SITE PLAN APPLICATION  
218-220 WASHINGTON AVENUE  
WRITTEN SUBMISSION S-7 INTERNAL VEHICLE MOVEMENTS

Internal Vehicle Movement  
into ADA Access Aisle

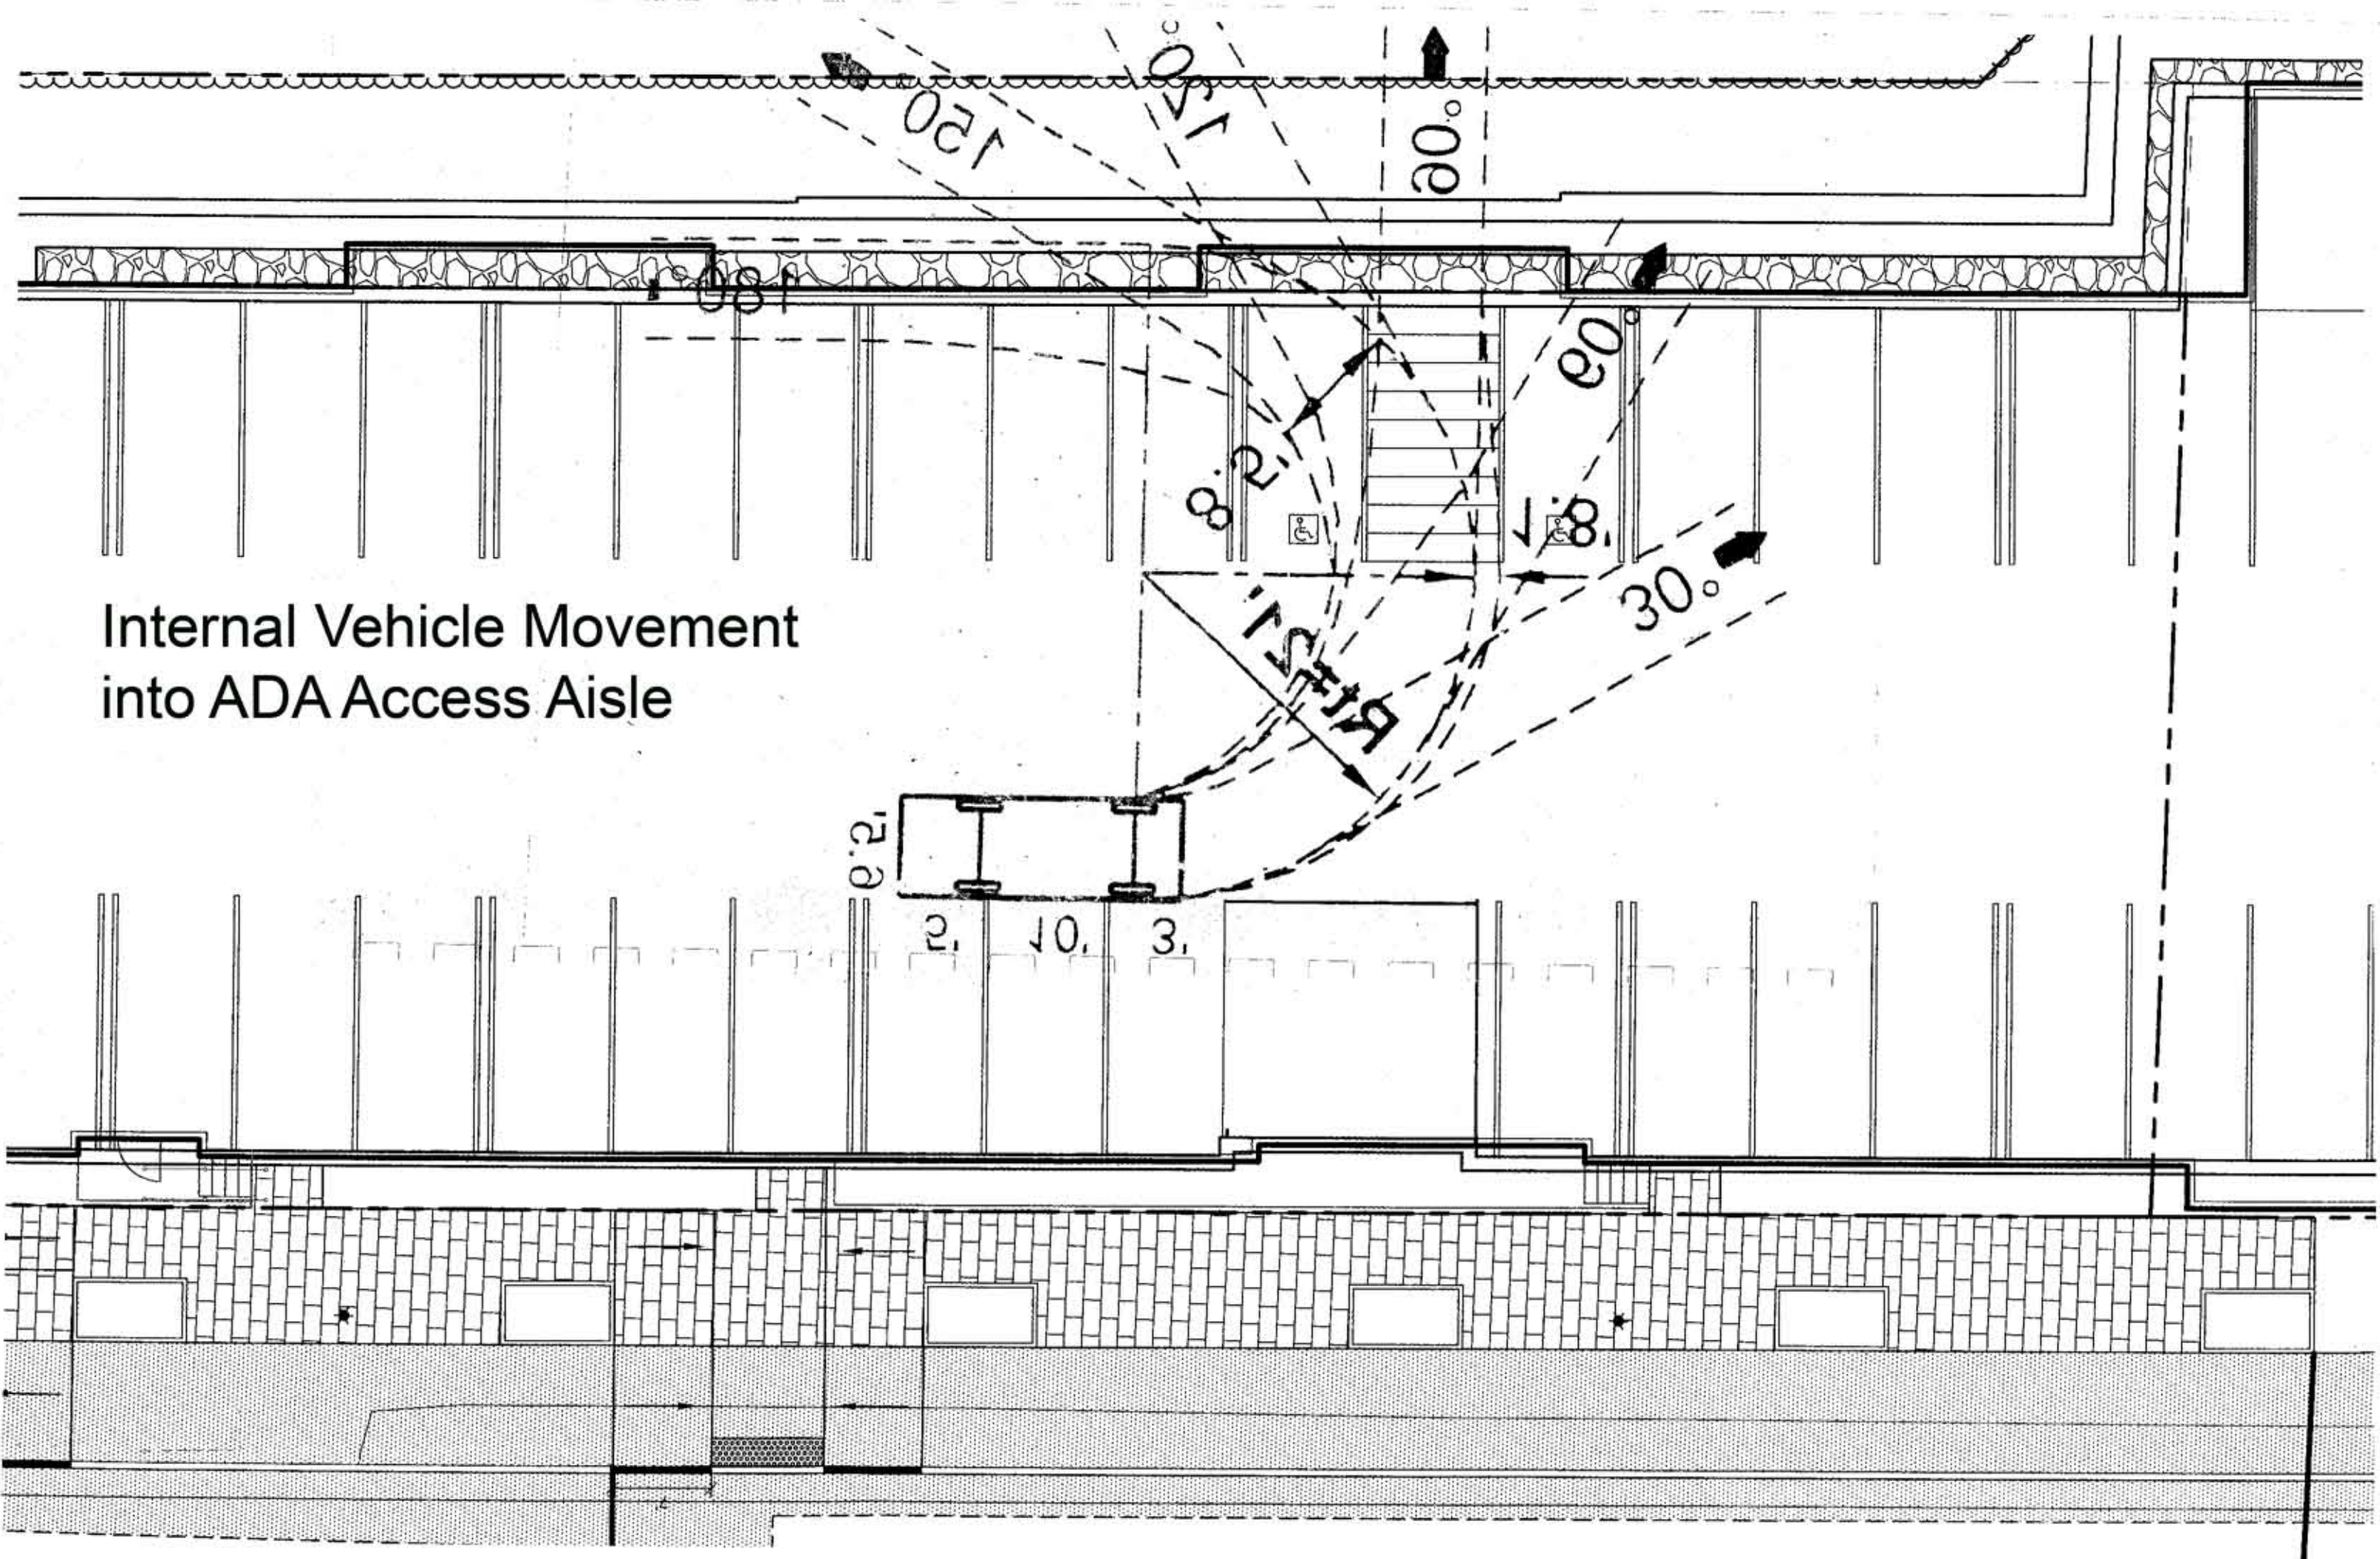
THE TRAFFIC PEER REVIEW COMMENTS REQUEST THAT THE APPLICANT SHALL CONFIRM THAT ALL INTERNAL VEHICLE MOVEMENTS CAN OCCUR WITHOUT HAVING TO BACK OUT OF THE SITE.

AS DEPICTED IN THE ATTACHED DIAGRAMS, A VEHICLE CAN TURN AROUND USING THE ADA ACCESS AISLE, WHICH WILL ALWAYS BE FREE OF CARS, EVEN IF ALL OF THE GARAGE PARKING SPACES ARE OCCUPIED.
